EARLY DESIGN GUIDANCE RECOMMENDATIONS

EARLY DESIGN GUIDANCE RECOMMENDATIONS

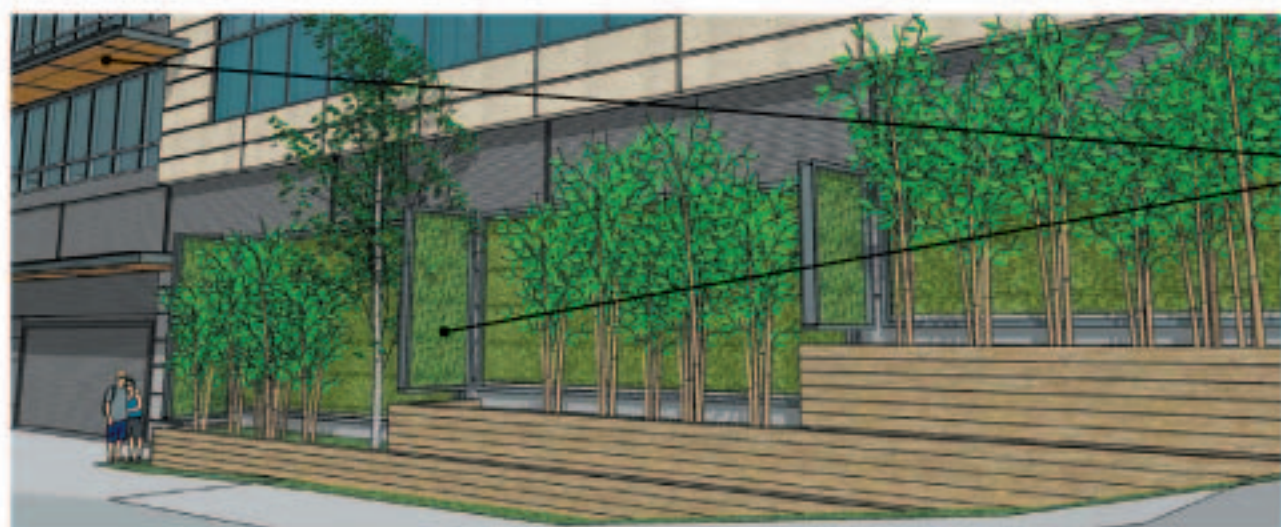
The site is uphill from the adjacent and downhill Lowrise zone. To create a sensitive transition to this less-intensive zone, the design should continue the proposed stepping of the building's alley façade and add this between the office first and second levels, or other design technique to achieve this goal. The proposed alley façade landscaping should be pursued, but because it serves to screen more than reduce the height, bulk and scale, can not be fully relied upon to address this guidance.

01 EAST ELEVATION
1" = 25'-0"

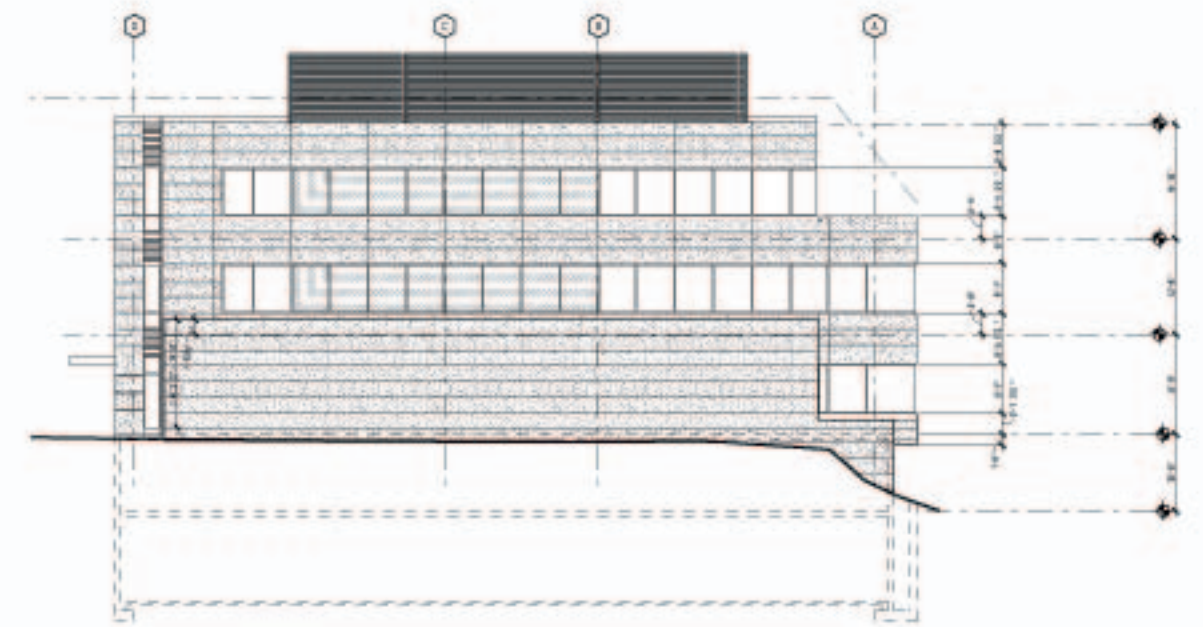
1. The Eastlake façade should include modulation and/or a variety of materials to visually reduce the length of the building.
2. The site's boundaries on three rights of way and location on a west facing slope should be taken advantage of to provide extensive interior day-lighting.
3. The proposed north to south oriented mechanical penthouse is at odds with the westerly views to the lake and mountains from the general area uphill to the east. Alternatives showing this structure broken into smaller increments or re-oriented so as not to create a visual wall should be included with the MUP proposal.

1. The proposed Eastlake façade design should include more modulation for a reduction in perceived building length.
2. The proposed upper level frame expression now appears to tower-over and minimize the visibility of the street level commercial frontage; this should not occur.

TRAFFIC FLOW WITH PARKING ACCESS AT EDGAR STREET

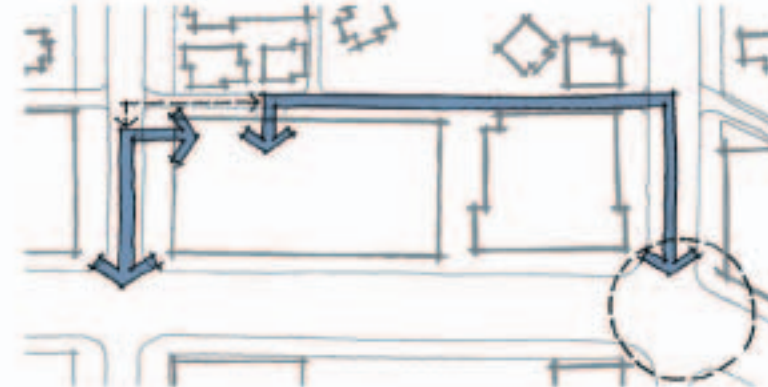
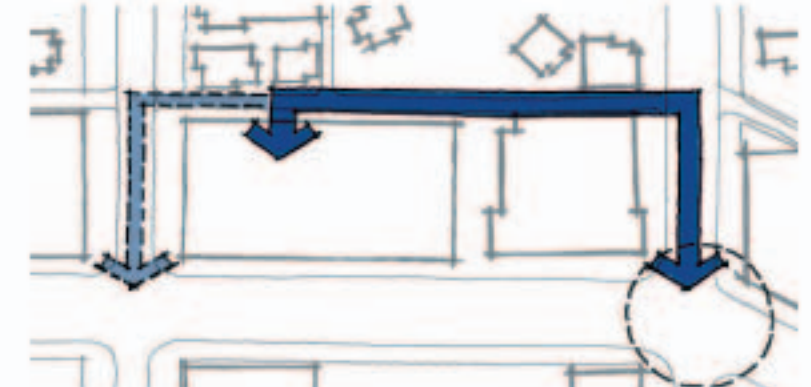
Because of its proposed proximity to the alley, the proposed Edgar Street driveway and garage entrance could be reduced below the Code required width to a size that will minimize the disruption of the pedestrian environment, but still allow safe vehicle travel. A Design Departure for this would be considered by the Board.
